P-13302

S3968

PARTY'S NAME	PALLAVI ENGINEERING COMPANY, BANGALORE
PARTY'S DRAWING No.	MODIFIED OF SECTION No:-28719
ALLOY & TEMPER	HE9 WP
DESCRIPTION	MISC. SECTION

DRAWING No.	SECTION No.
P-13302	-
S3968	S3968(ISSUE-2)
29642	29642

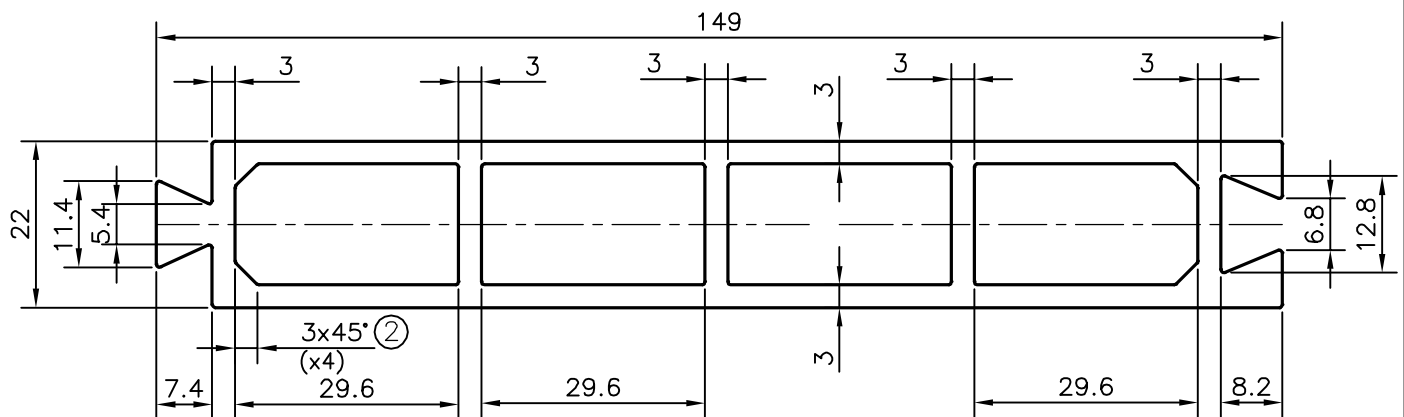
ISSUE-2 :-

3x45° CHAMFER ADDED IN MANDREL(4 PLACES)

WEIGHT ALSO CHANGED FROM 3.248 kg/m TO 3.296 kg/m
